## ADDENDUM NO. 1

### TULALIP BAY WATER SYSTEM IMPROVEMENTS PROJECT

**ADDENDUM NO. 1**  
**TULALIP BAY WATER SYSTEM IMPROVEMENTS PROJECT**  
**REVISIONS TO CONTRACT DOCUMENTS**

**W22**

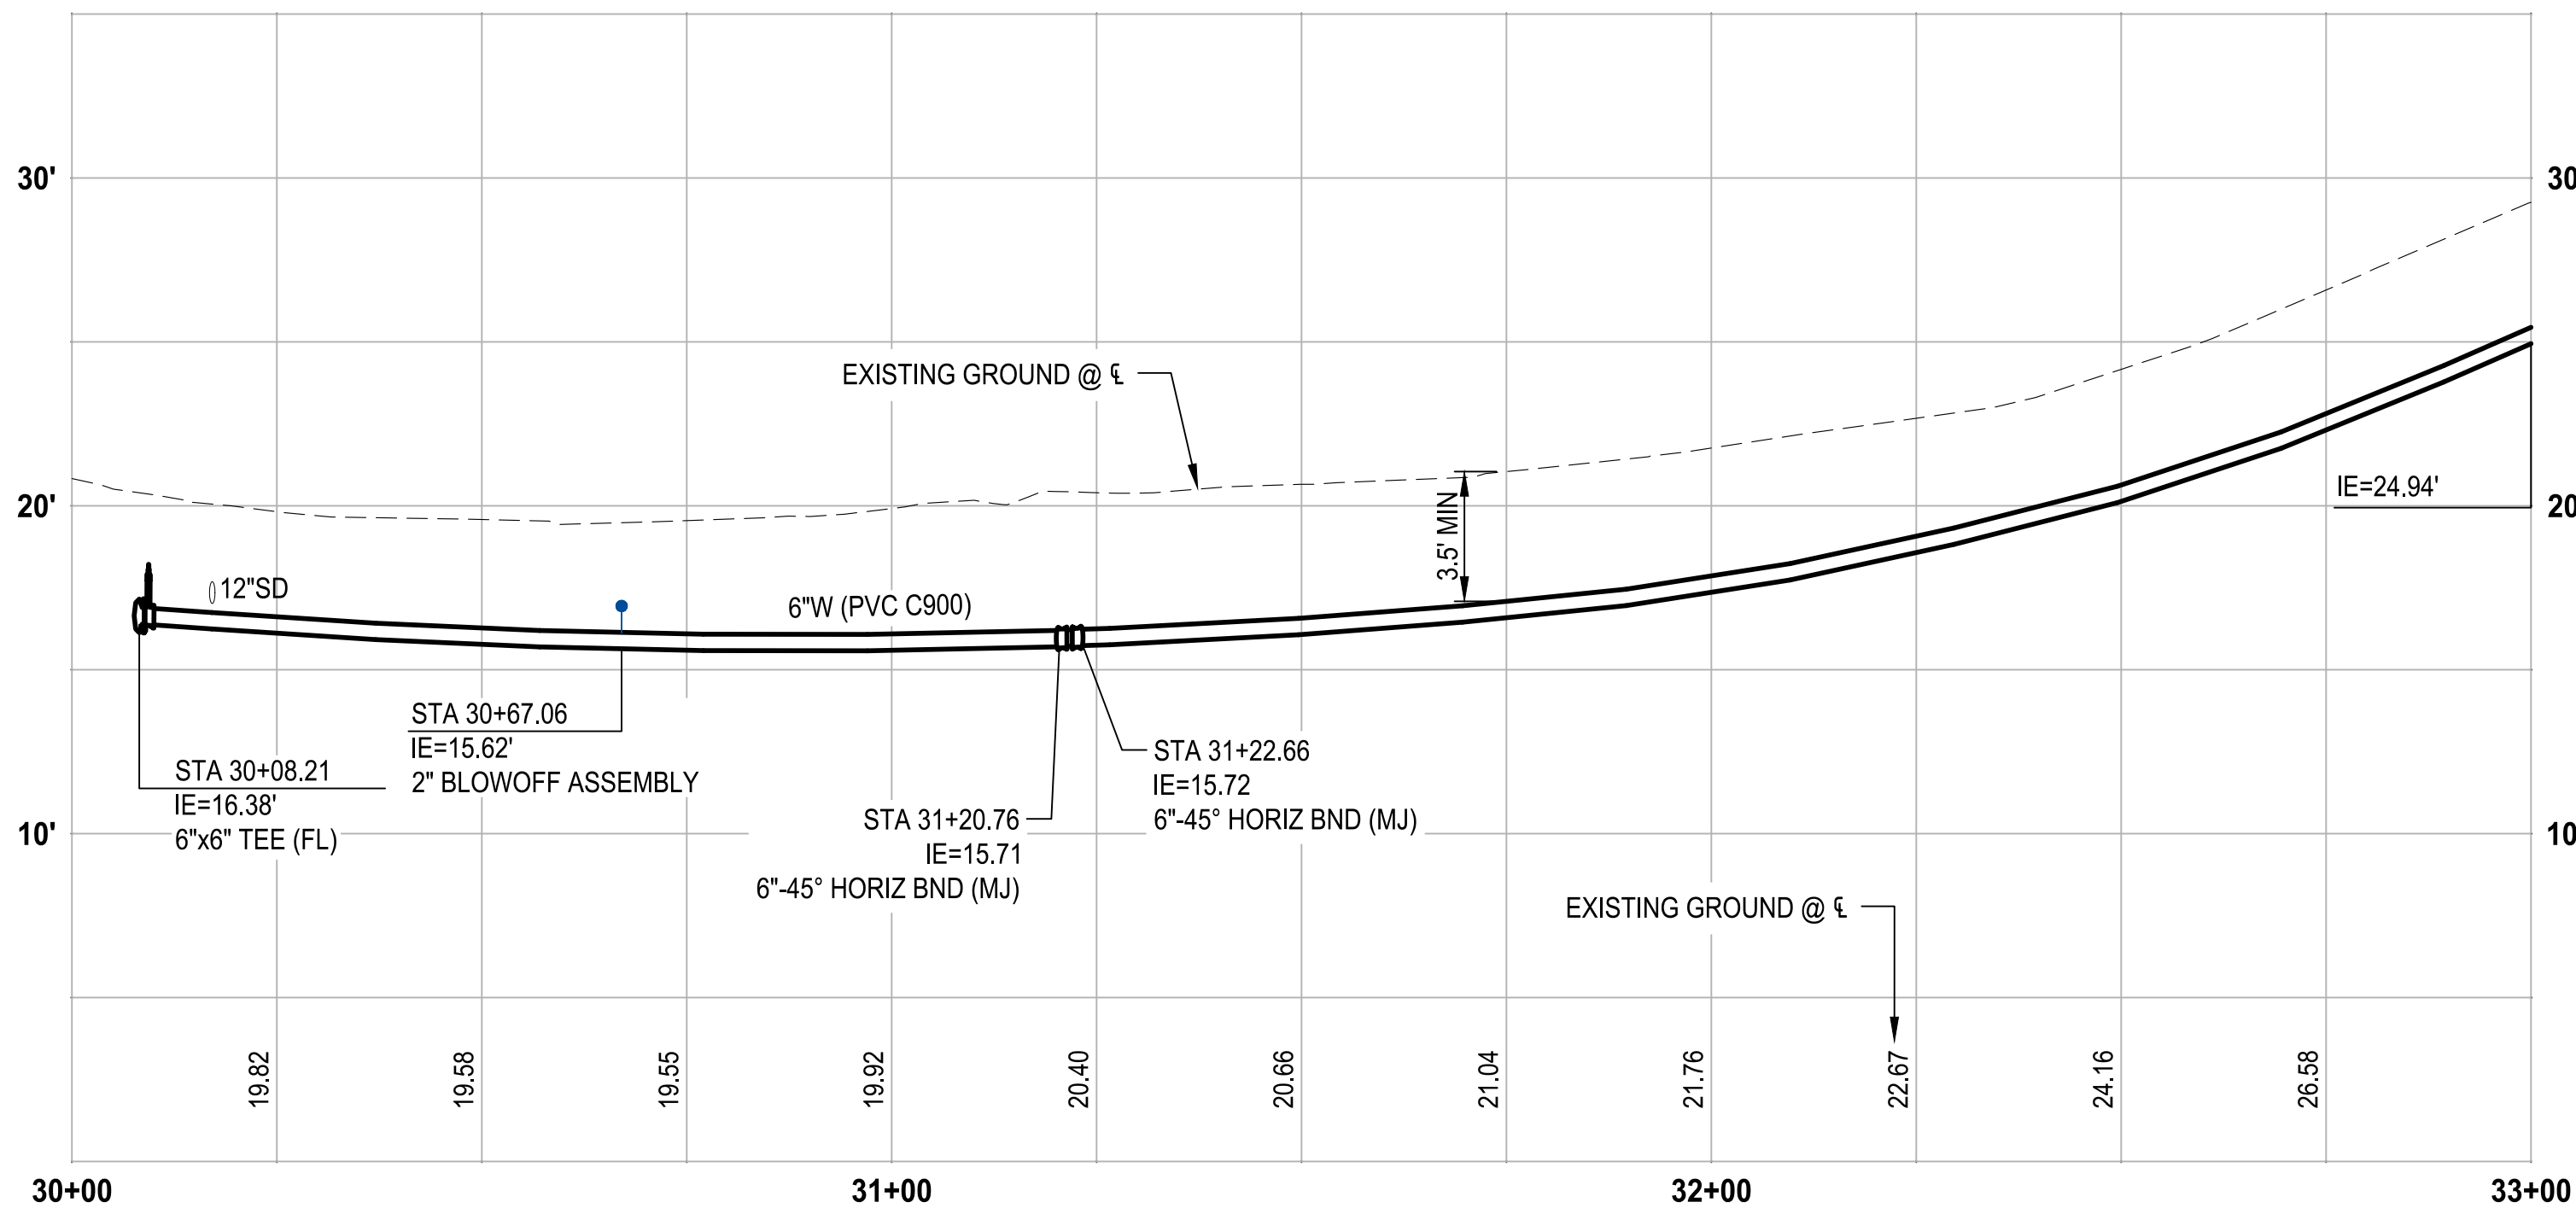
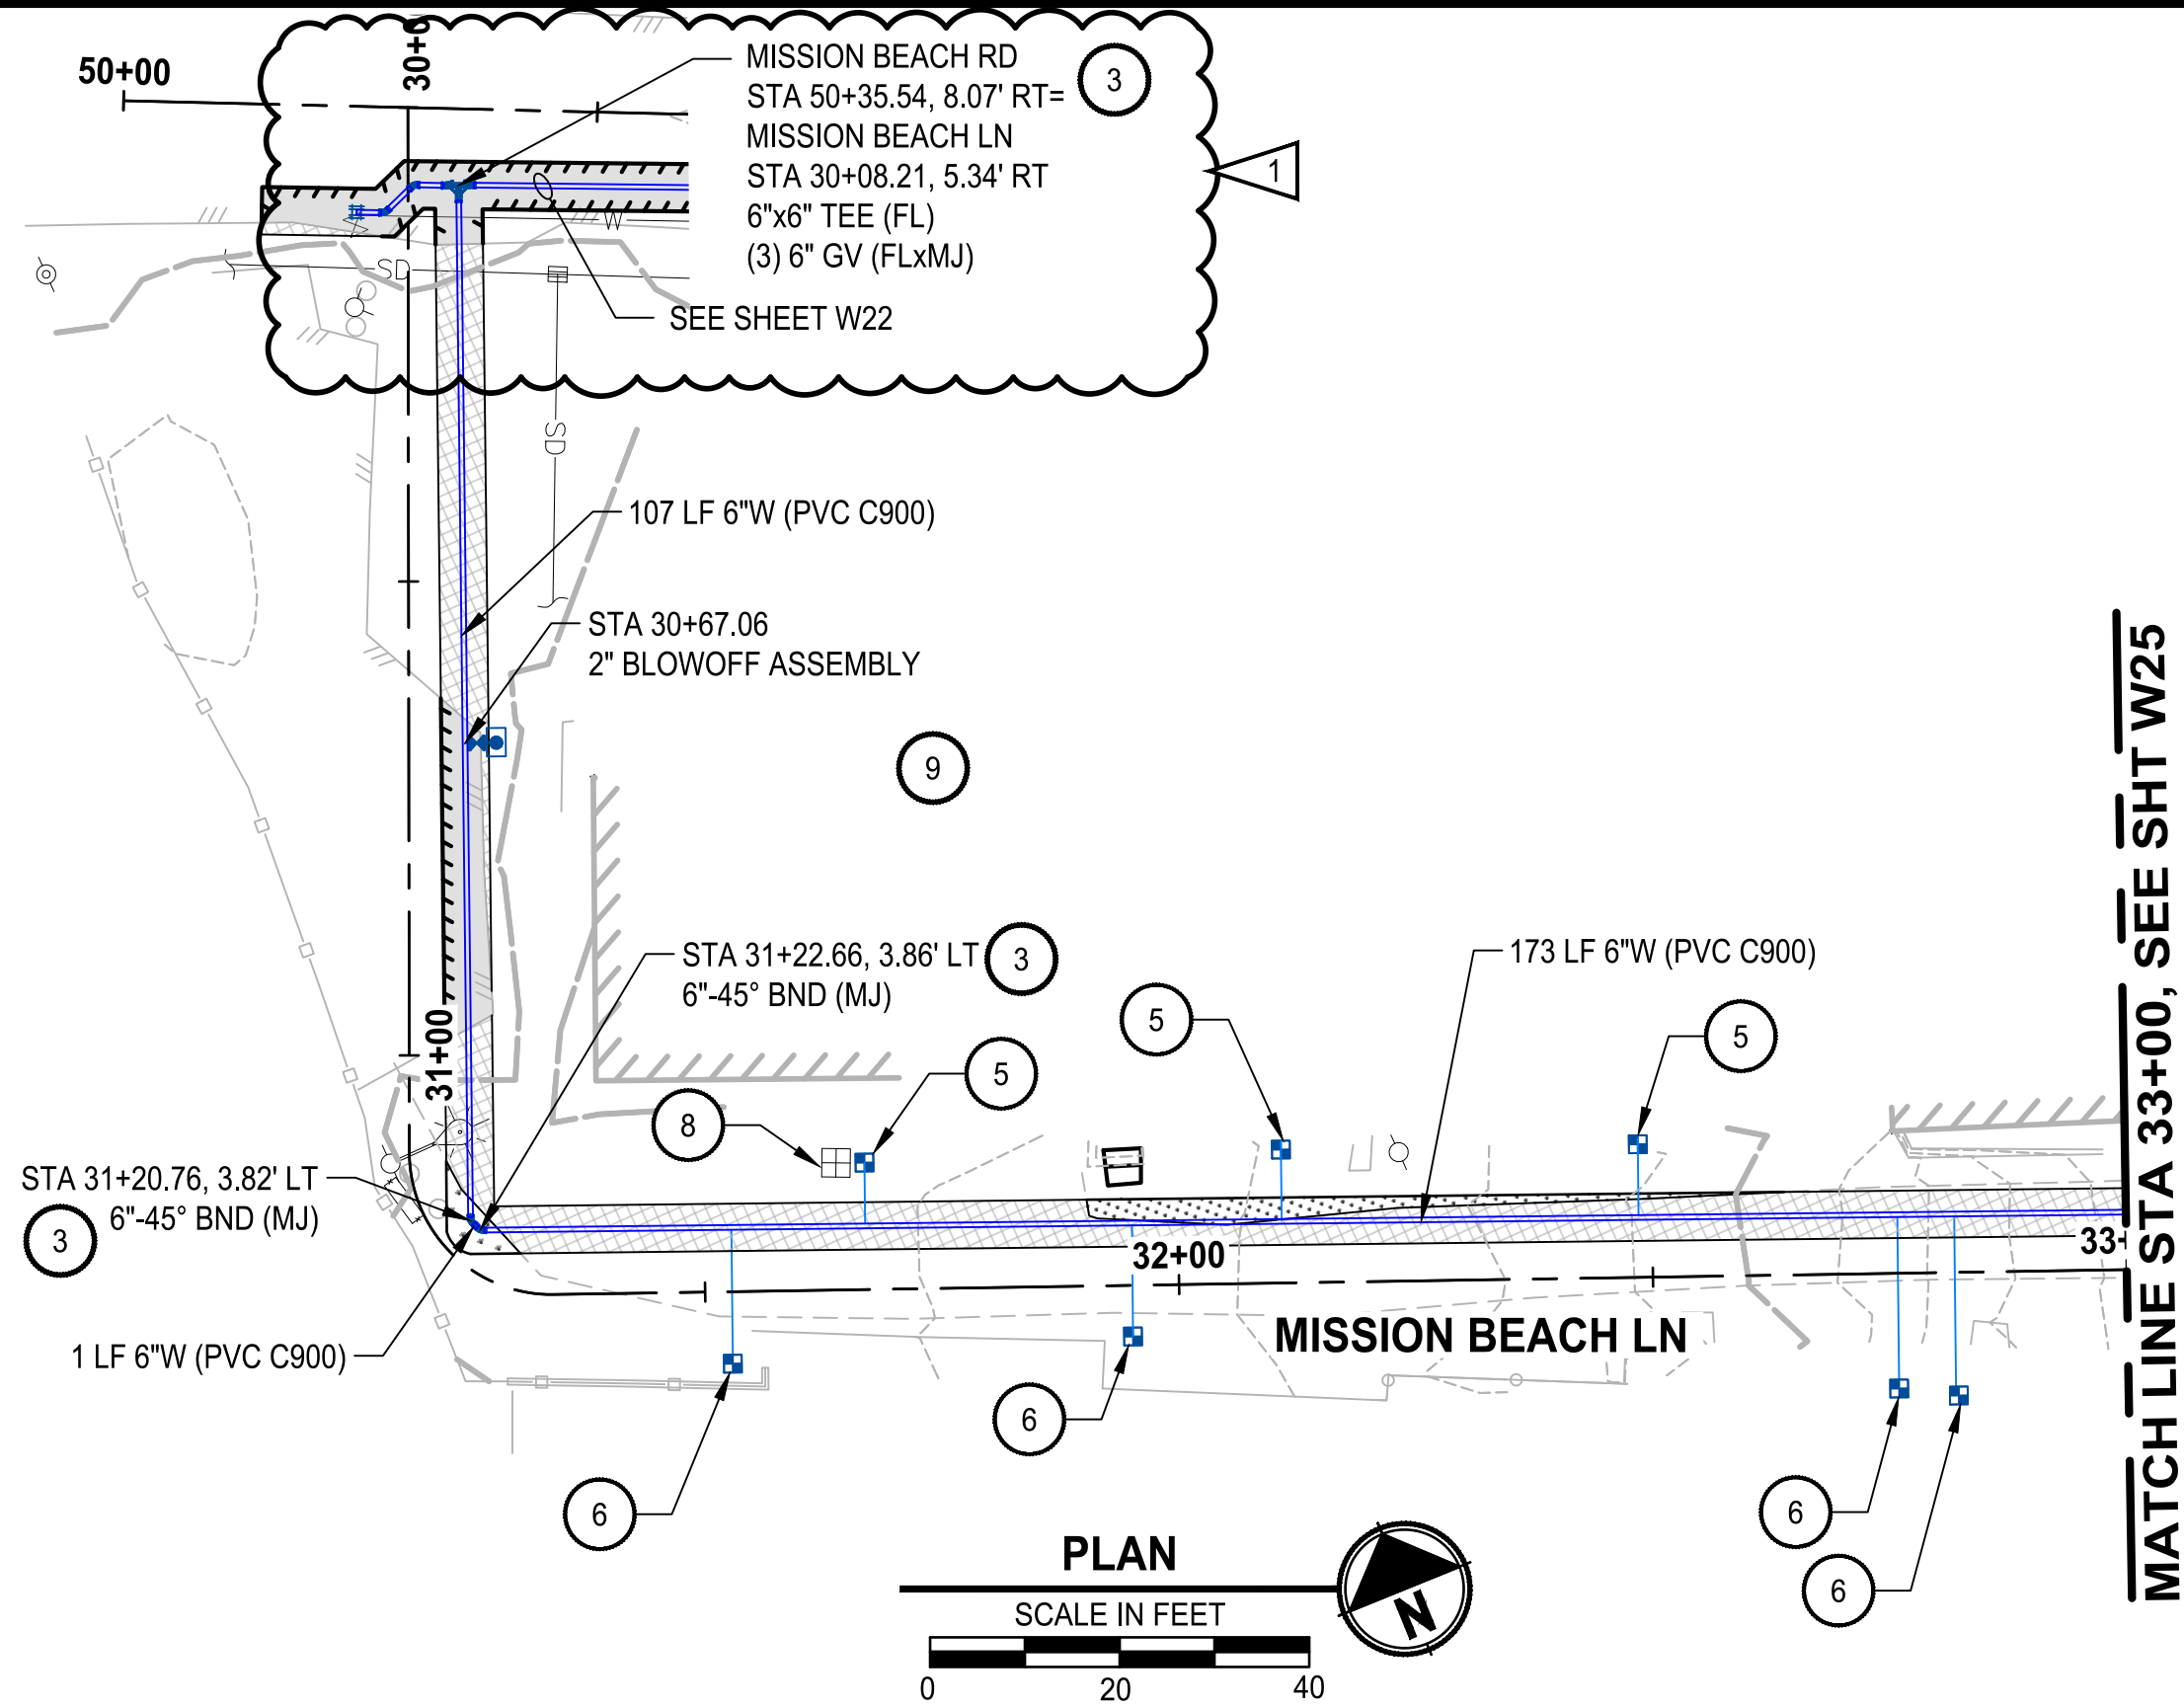
- On Sheet W22:
  - Callout at STA 50+30.81, 8.14' RT updated to "MISSION BEACH RD, STA 50+30.81, 8.14' RT, 6"-45° BND (MJ)"
  - Callout at STA 50+35.54, 8.07' RT updated to "STA 50+35.54, 8.07' RT=, MISSION BEACH LN, STA 30+08.21, 5.34'RT, 6"x6" TEE (FL), (3) 6" GV (FLxMJ)"
- On Sheet W24:
  - Callout at STA 30+08.21, 5.34' RT updated to "MISSION BEACH RD, STA 50+35.54, 8.07' RT=, MISSION BEACH LN, STA 30+08.21, 5.34'RT, 6"x6" TEE (FL), (3) 6" GV (FLxMJ)"
